ITEM 5. DEVELOPMENT APPLICATION: 130-134 ELIZABETH STREET SYDNEY**FILE NO: D/2014/2013****DEVELOPMENT APPLICATION NO: D/2014/2013****SUMMARY**

Date of Submission:	23 December 2014
Amended:	23 June 2015 and 3 July 2015
Applicant:	CBUS Property 130 Elizabeth Street Pty Ltd
Architect:	Bates Smart
Developer:	Hyde Development Nominees Pty Ltd
Owner:	130 Elizabeth Street Pty Ltd
Cost of Works:	\$115,555,000
Proposal Summary:	<p>The subject application seeks consent for a 38-storey mixed use development, and encompasses the following:</p> <ul style="list-style-type: none">• demolition of existing structures;• excavation for basement levels;• vehicular access off Clarke Street;• 140 residential apartments;• 190sqm of retail floor space, comprising 4 retail premises;• 92 car parking spaces;• relocated pedestrian entry to Museum railway station; and• landscaping, public art and public domain works.

Figure 22: Aerial view of amended Stage 1 DA building envelope, which illustrates the chamfered edge on the southwestern corner

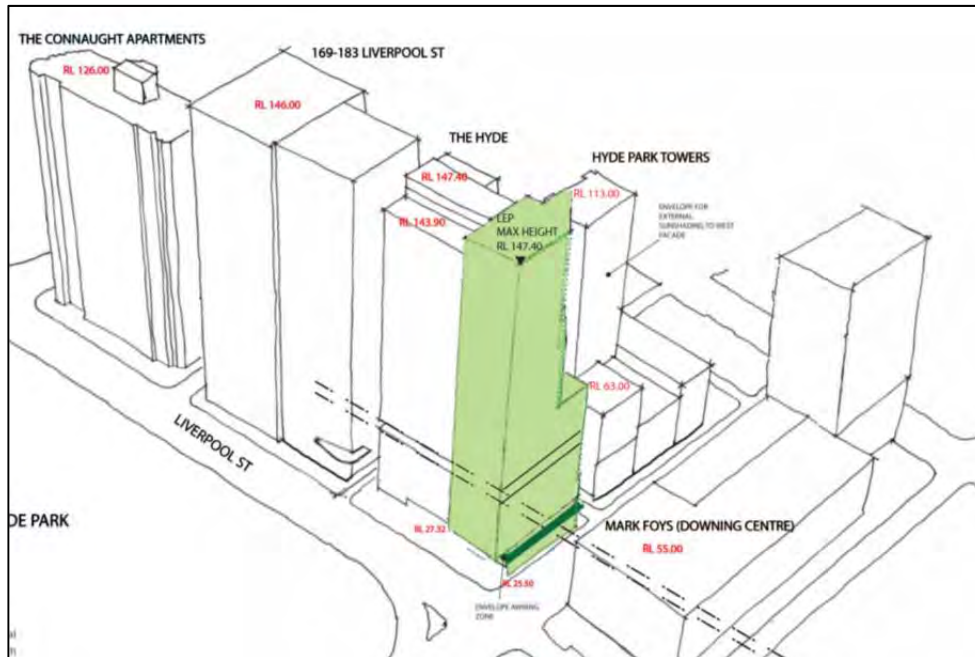
- (b) further modelling was undertaken during this assessment to determine that if the envelope was chamfered off in the southwestern corner of the tower between Levels 14 to 36, then the affected apartments in 'Hyde Park Towers' would retain 1 hour 50 minutes or greater of direct solar access between 9.00am and 3.00pm on the winter solstice, which is generally consistent the solar access provisions of Sydney DCP 2012 and SEPP 65/RFDC. This was assessed as acceptable in the Stage 1 development application based on the existing site constraints and the extremely dense CBD environment (refer to **Figure 22**, below, which illustrates the chamfer of the envelope);

- (c) The application was considered by the City's Design Advisory Panel (DAP), who supported the chamfering of the envelope and creating a more slender tower in order to preserve the amenity for residents in 'Hyde Park Towers'. In addition to the amenity impacts noted above, DAP also noted that they were of the view that this site could accommodate additional height, to align with the height of the architectural roof feature of 'The Hyde'. This was due to:

Figure 23: Stage 1 DA building envelope massing (i.e. 110 metres) as viewed from Hyde Park

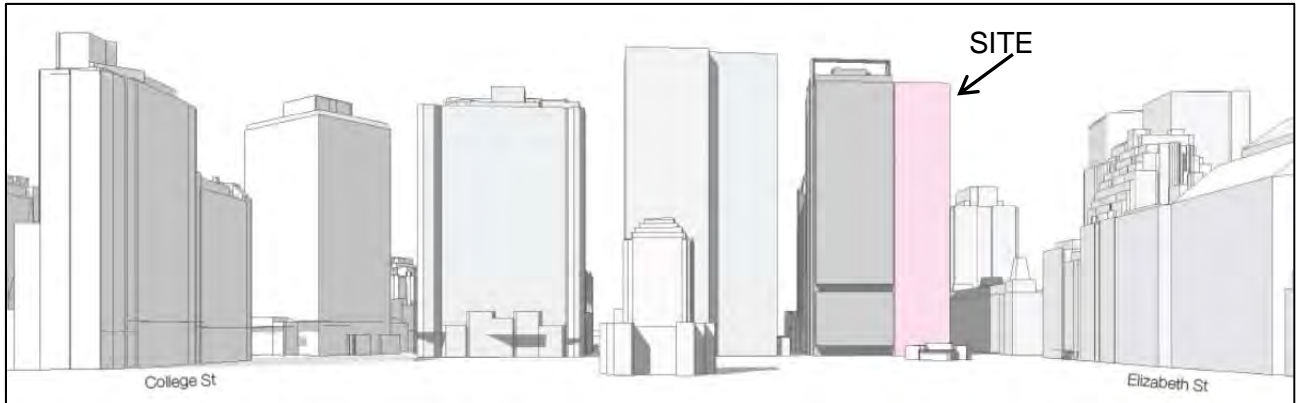
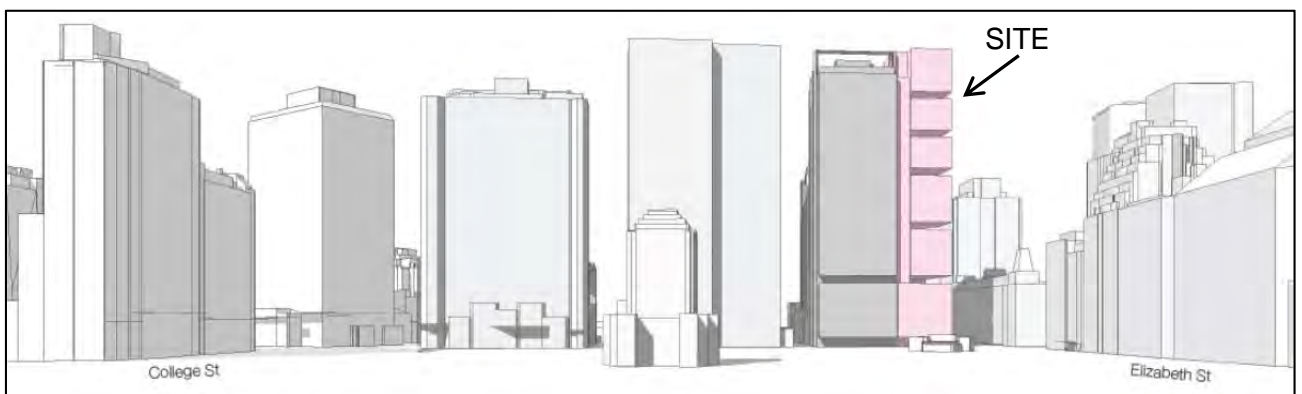
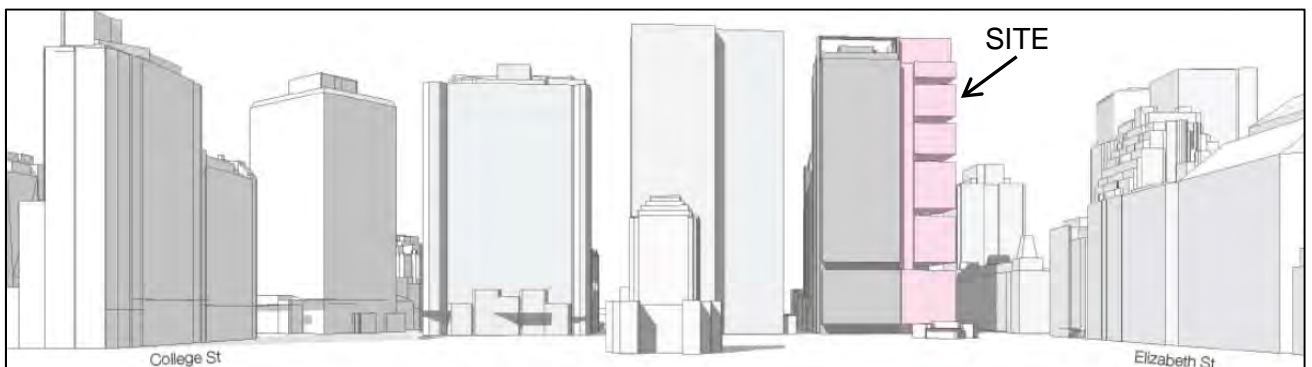
63. **Figures 23 to 25**, illustrates envelope massing prepared by the applicant to illustrate a comparison in the massing between the approved Stage 1 DA, the Stage 2 DA as originally lodged and as modified with the upper 2 levels setback.

64. Based on the above, the Applicant was advised in June 2015 that the proposal required design refinement to address impacts associated with the additional height, which related to:
- (a) the obstruction of westerly district views and outlook from 'The Hyde' penthouse, which occurred as a result of the non-complying element of the building; and
 - (b) bulk and scale of the upper levels on this visible corner site, with this massing being inconsistent with the upper levels of 'The Hyde'.

Figure 29: An aerial view (looking northeast) of the amended massing of the upper 2 levels of the building and the relationship with the principal open space of the penthouse apartment of 'The Hyde'

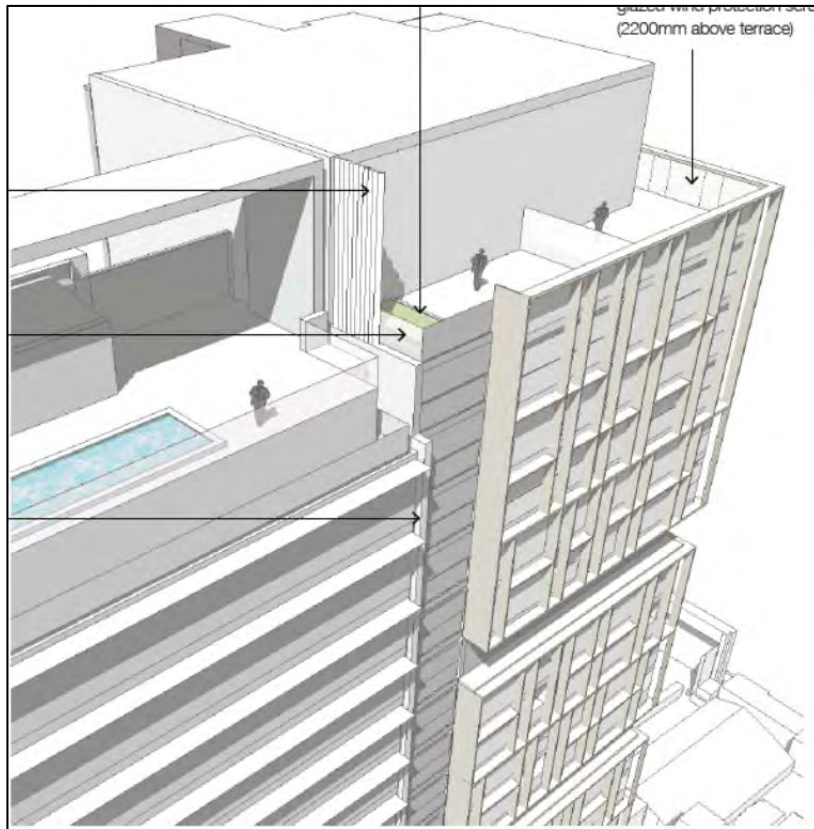
66. **Figures 27 to 30**, below, illustrate the comparison of the originally lodged and proposed scheme with relation to the setback of the upper levels.

Figure 32: View of the Elizabeth Street elevation illustrating the extent of breach to the building height development standard

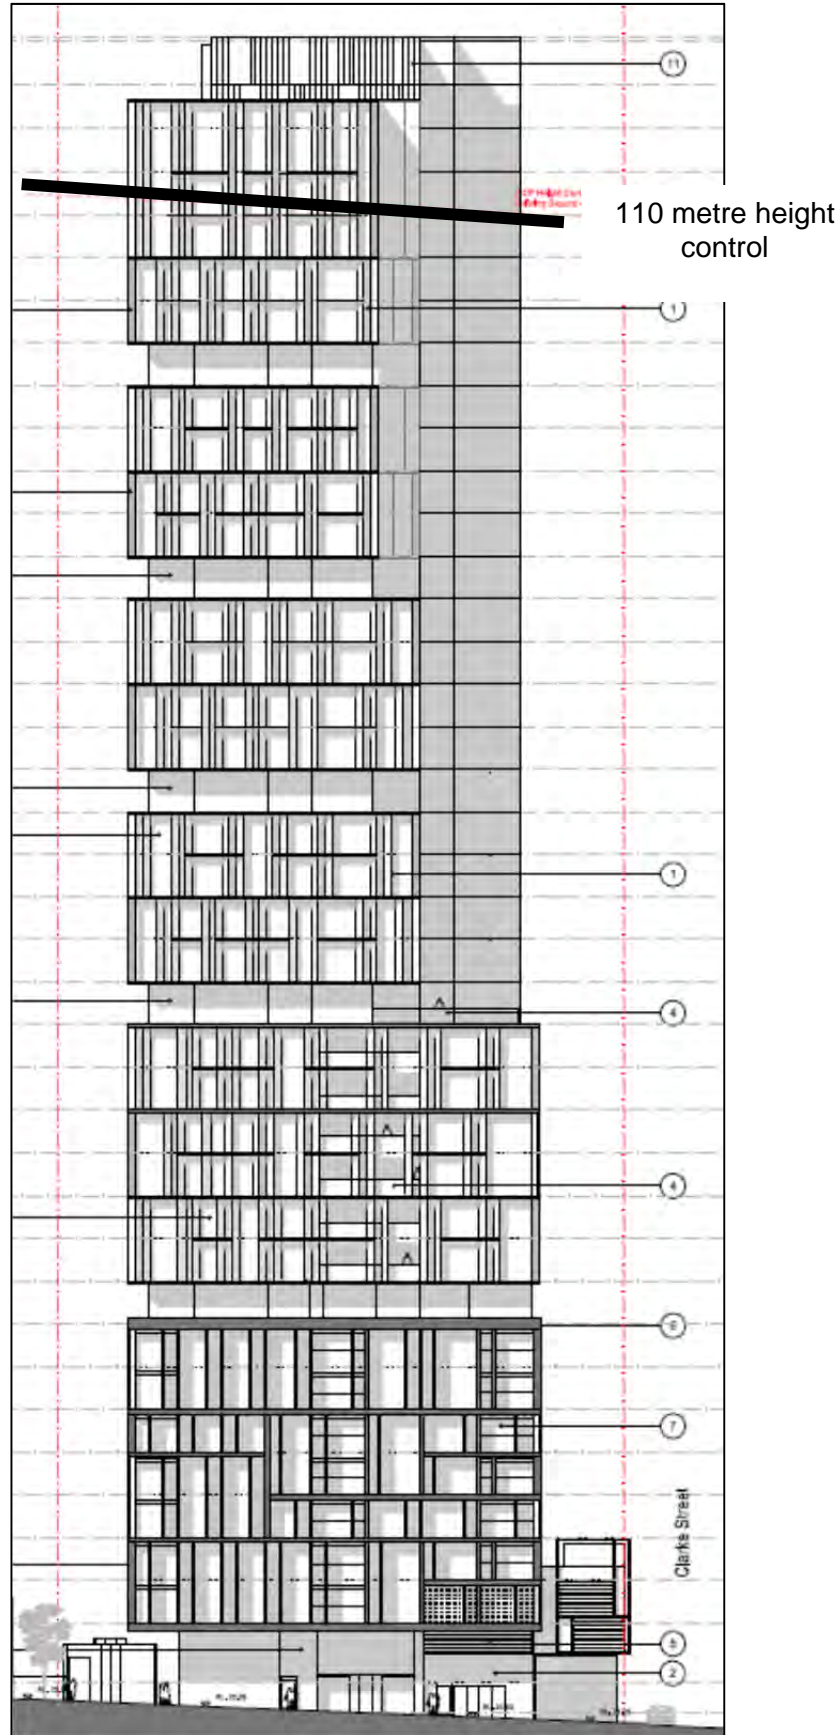
74. In order to demonstrate whether strict numeric compliance is unreasonable and unnecessary in this instance, the proposed exception to the height development standard has been considered against the objectives and provisions of Clause 4.6 in the following table:

Figure 34: Illustration of the proposed new circular glazed pedestrian entry to Museum Station

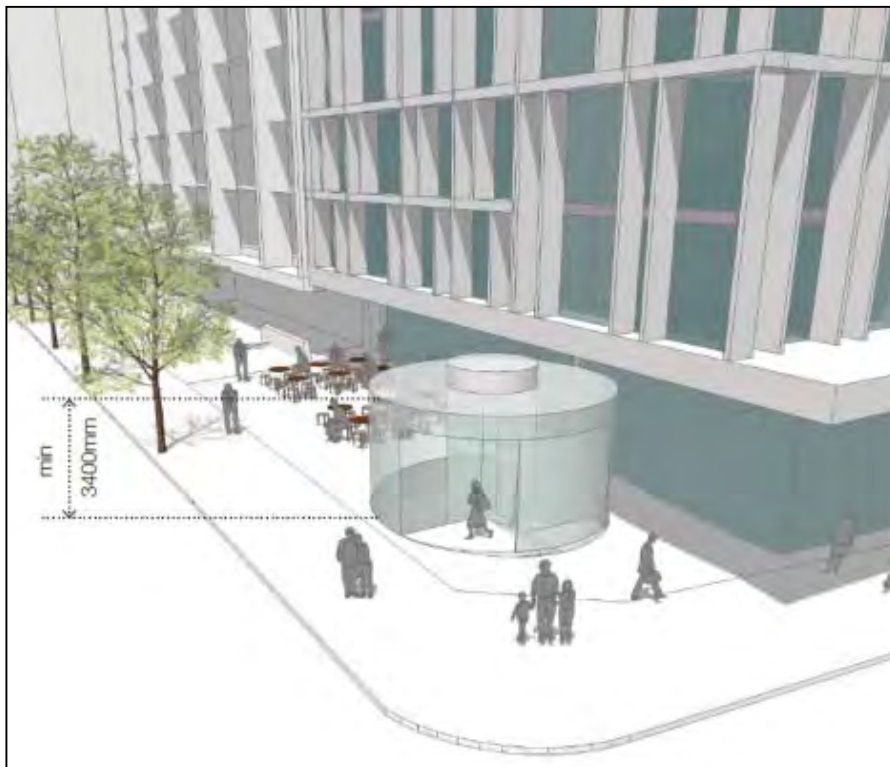
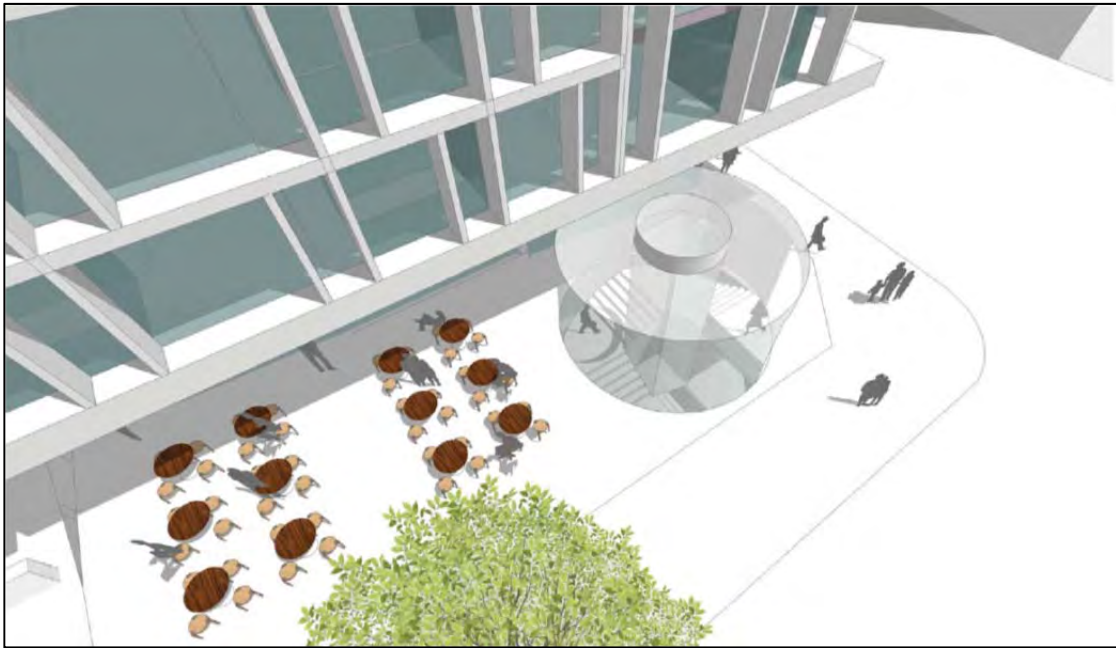
91. A number of submissions have been received raising concerns with the proposed station entry, notably the removal of the escalators and replacement with traditional stairs and the impacts on accessibility to the station.

Figure 36: A sectional drawing illustrating the proposed relocated station entry and the impediments of the existing stairs and level changes within the underpass tunnel

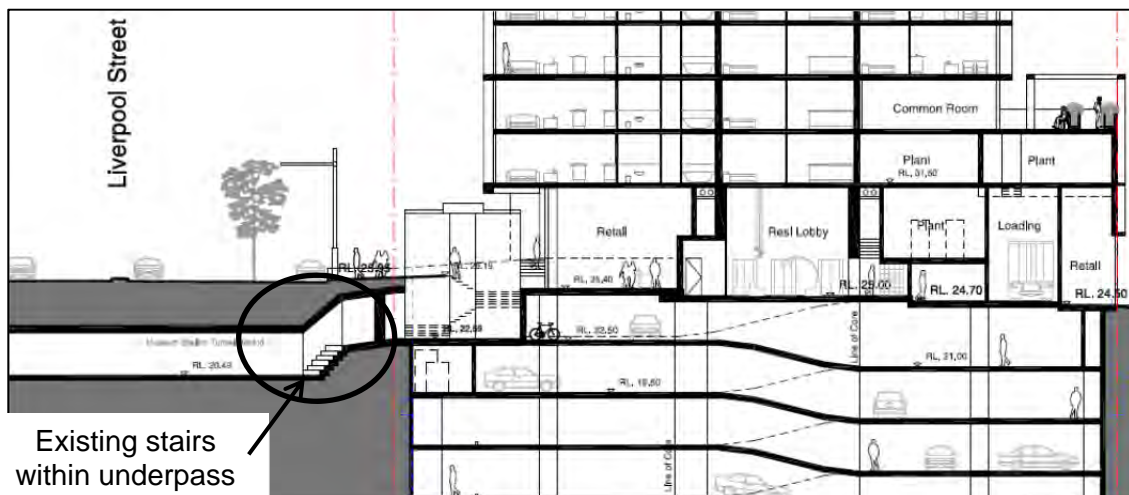
92. It is agreed that accessibility to the station is a parameter issue, however, the position of Transport for NSW and the City’s assessment staff is that the existing entry does not, nor has it ever, provided access to Museum Station for people with a disability. The existing heritage listed pedestrian underpass tunnel is not accessible and contains a series of 8 stairs (refer to **Figure 36**, below) between the subject site and the concourse of Museum Station. The existing tunnel is constrained and does not contain an adequate head height clearance to facilitate the removal of these stairs and replacement with a compliant gradient ramp. Furthermore, these stairs are located outside the boundaries of the site.

Figure 37: The proposed floor plan and roof top terraces of the penthouse apartments on Level 37 of the subject development

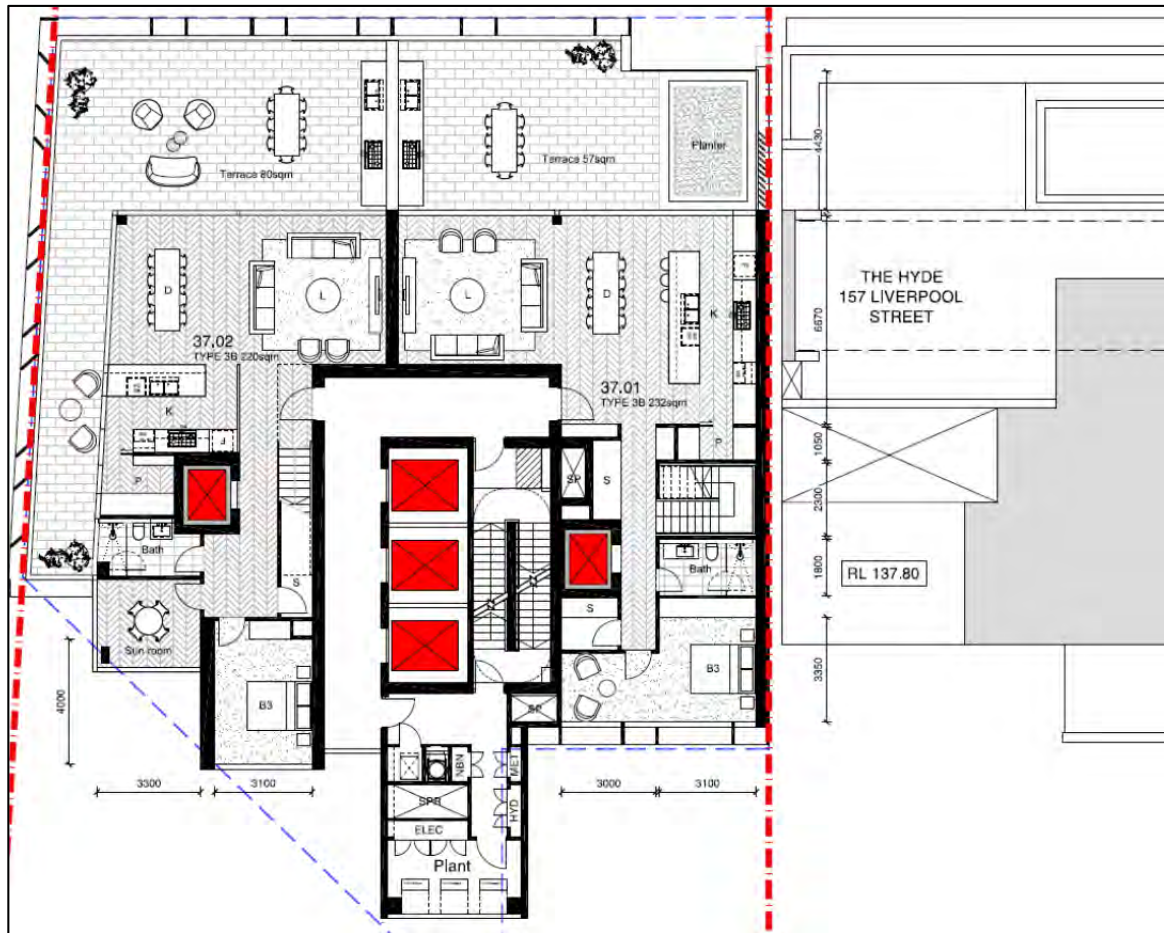
97. The amendments made to the scheme has seen the creation of two roof terraces on Level 37 to service the two penthouse apartments (refer to **Figure 37**, below).

Amended plans shall be submitted to reduce the height of the screen/parapet around the perimeter of the Level 37 roof terraces to no higher than 1.6 metres above the finished floor level of the terraces.

Figure 39: Section drawing illustrating the relationship of the proposed penthouses terraces with that of 'The Hyde' and the indicative 2.2 metre high wind screen

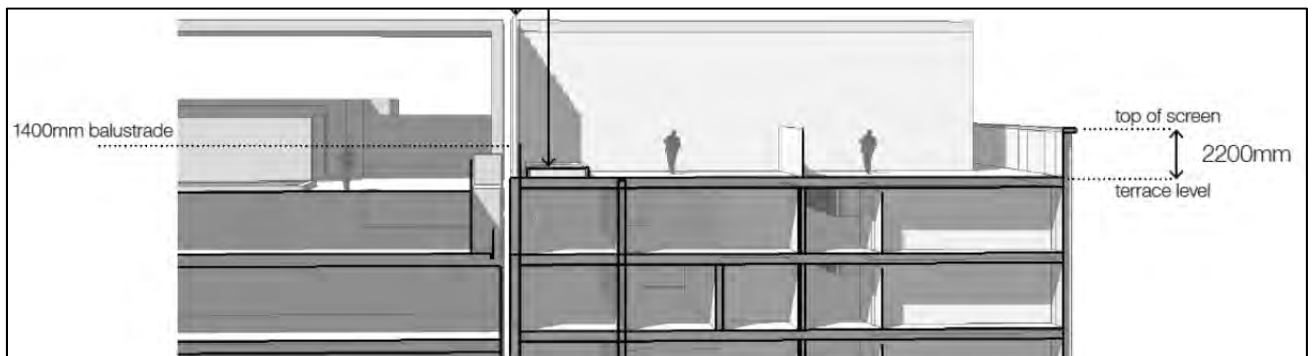
98. The amended scheme incorporates a 2.2 metre high wind screen/parapet around the northern and western perimeter of the Level 37 roof terraces (refer to **Figures 38 and 39**, below).

100. Whilst it is agreed that some form of wind mitigation measures would be required to these terraces, after reviewing the original wind impact assessment and supplementary statement, it is considered that insufficient justification has been provided to support a wind screen at a height of 2.2 metres above the terrace floor level. Based on the information available, it is recommended that a design modification condition be imposed reducing the height of these screens to a maximum of 1.6 metres from the finished floor level. This design modification will result in the parapet height being more closely aligned with the parapet and balustrade height of 'The Hyde'.
